**CITY OF MERCED PROJECT NO. CP220061  
CHANGE ORDER NO. 3**

PROJECT NAME: Community Park 42

**REASON FOR CHANGE ORDER:**

Additional work to add 2 additional soccer fields, 2 basketball courts. Quantity adjustment for additional asphalt per the contract unit price. Add Musco Lights, and additional work.

Sheet  
**C1.3**  
 12 of 75

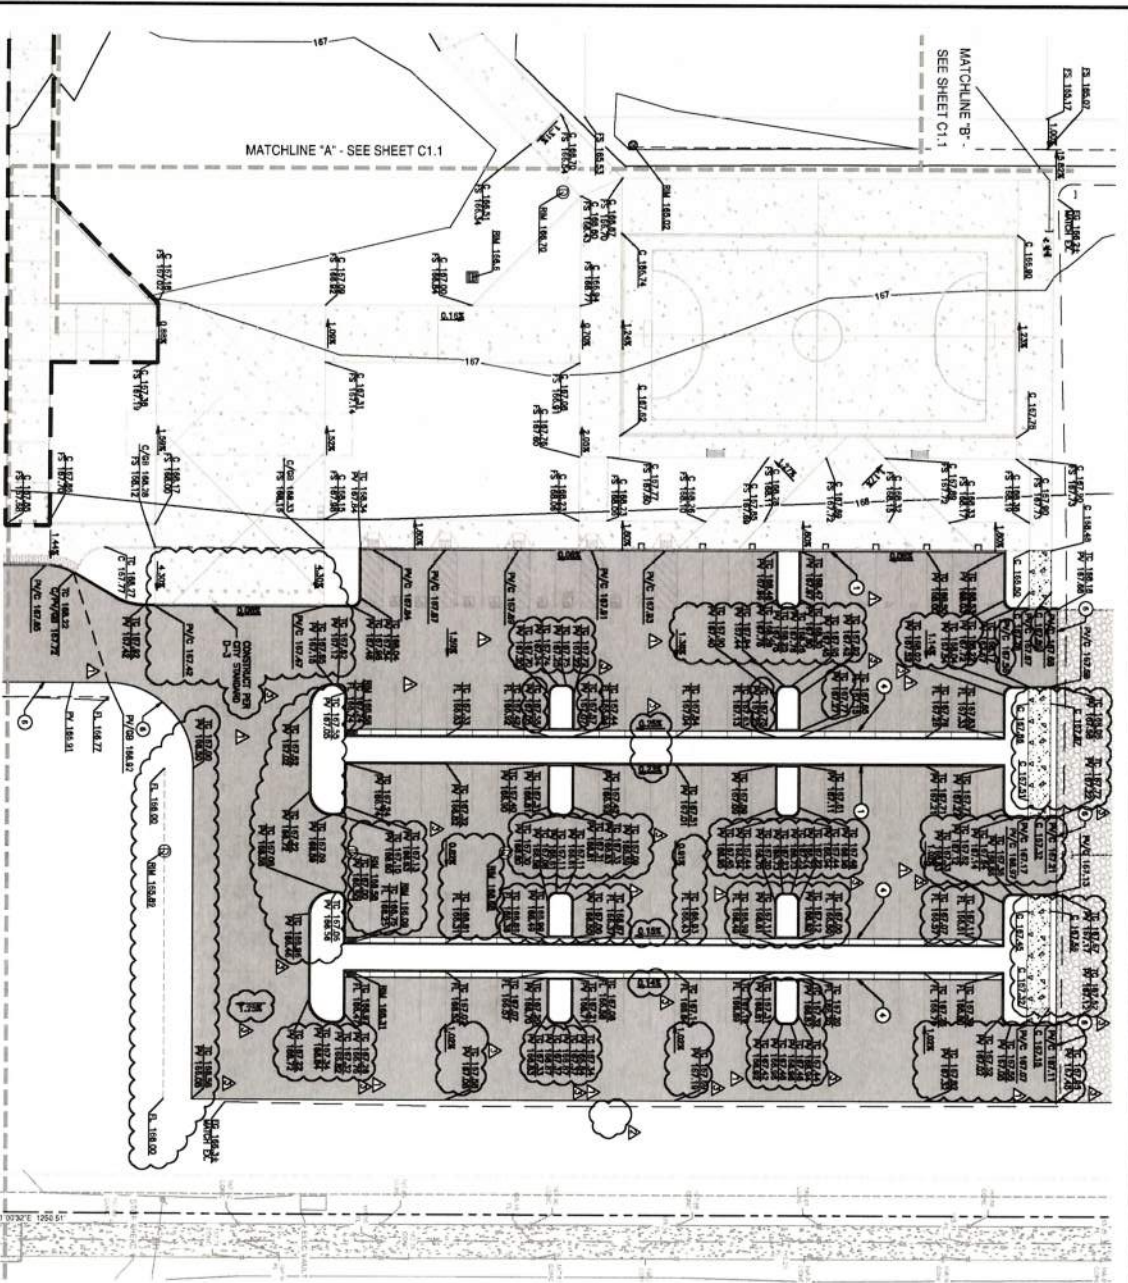
Attn: Joe Cardoso, PLS  
 Project: Community Park 42  
 Subject: PCO #5 – Revisions to Parking Lot & Curb Grades, & futsal court grades

Please find the below pricing. APC will provide all labor, equipment, materials, bonds, and incidentals to furnish and install the revisions to the parking lot, & grade changes at the curbs and futsal court.
